Final Drainage Report

Double Spur Ranch Minor Subdivision 12420 Meridian Rd, Colorado Springs, CO 80908

Add PCD File No. MS-235

Prepared: July 11th, 2022

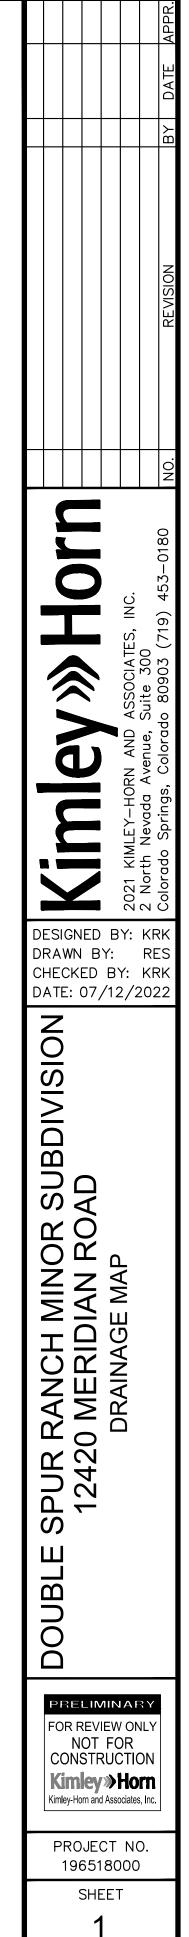
Provide proposed runoff values in a summary table.
